Comment Set B  
City of Shafter

**RE: Proposed Mitigated Negative Declaration for Pacific Gas & Electric Company's  
Seventh Standard Road Substation Project (Application No. A.09-03-004)**

## Responses to Comment Set B City of Shafter

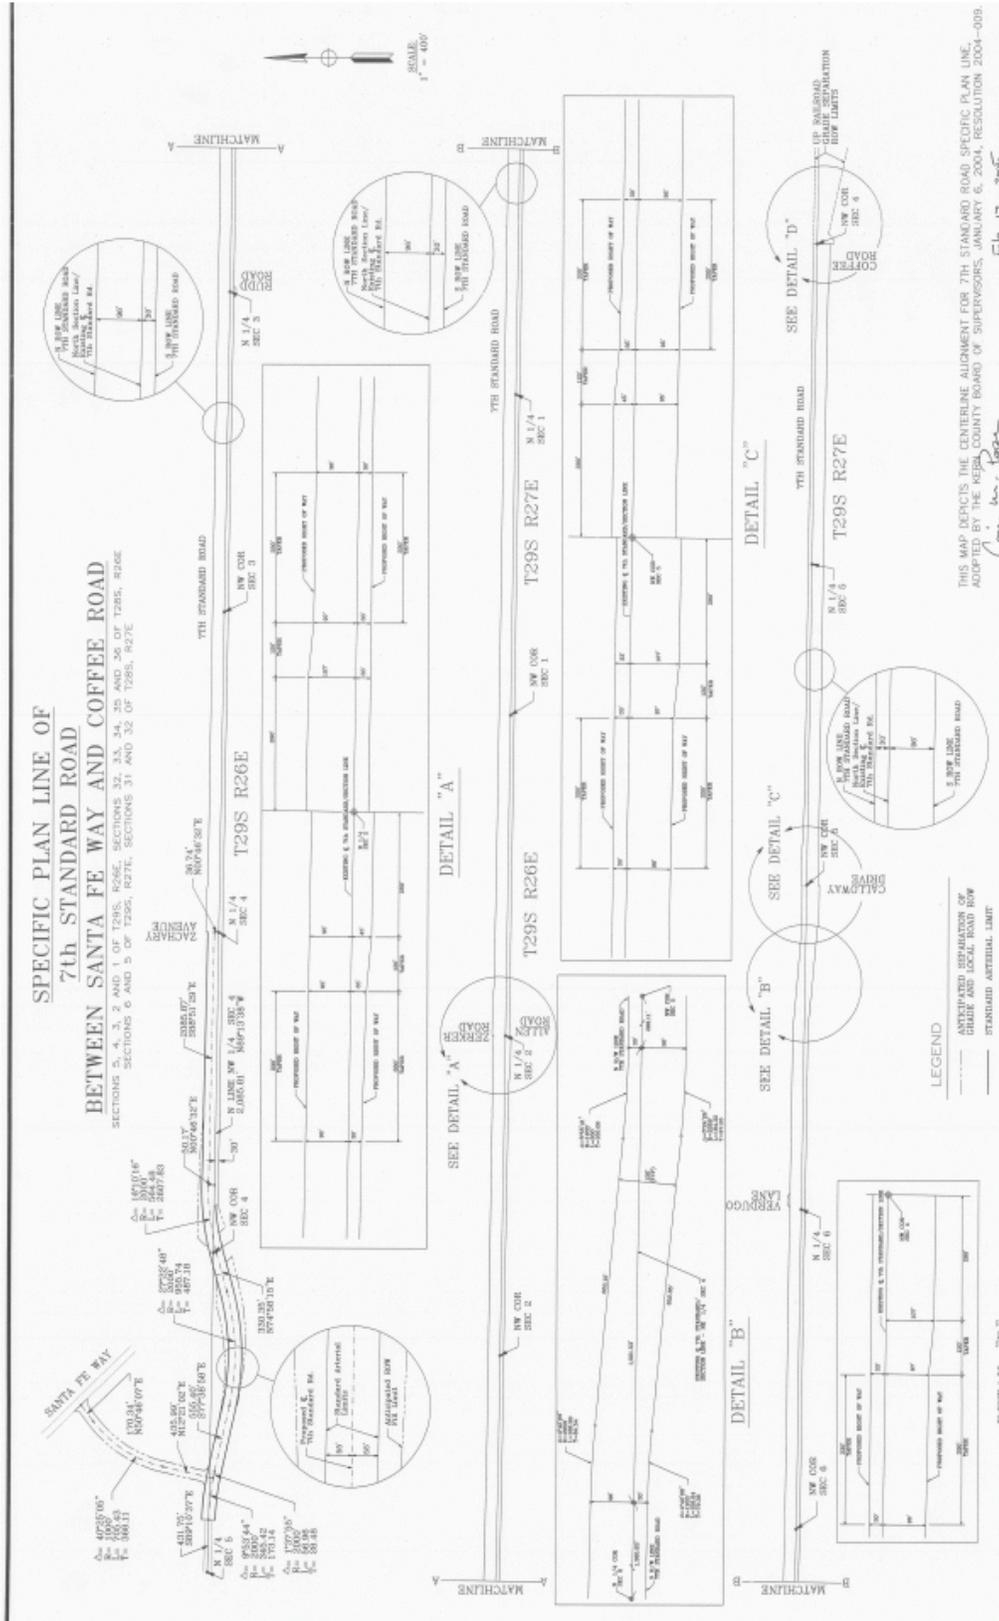
Section B.3.1 in the Initial Study, pages B.3-1 to B.3-14, does not identify the adopted Seventh Standard Road Specific Plan Line. Both the City of Shafter and the County of Kern have adopted this Specific Plan Line which establishes a 126 foot wide planned right-of-way for Seventh Standard Road from Coffee Road to just west of Santa Fe Way. The Initial Study needs to include this document in its analysis of the project's potential significant impacts on the environment. In particular, the proposed installation locations of the TSPs in relation to the adopted Specific Plan Line need to be addressed. A copy of the adopted Seventh Standard Road Specific Plan Line has been e-mailed to you at seventhstandard@aspenerg.com.

We would greatly appreciate it if all the above environmental documents are revised to provide a single consistent project description for the proposed TSPs. We will need additional time to review and comment on the revisions to adequately analyze the project's potential significant impacts on the environment.

B-6 The "Specific Plan Line of 7th Standard Road Between Santa Fe Way and Coffee Road" is noted. Please see Response to Comment B-4.
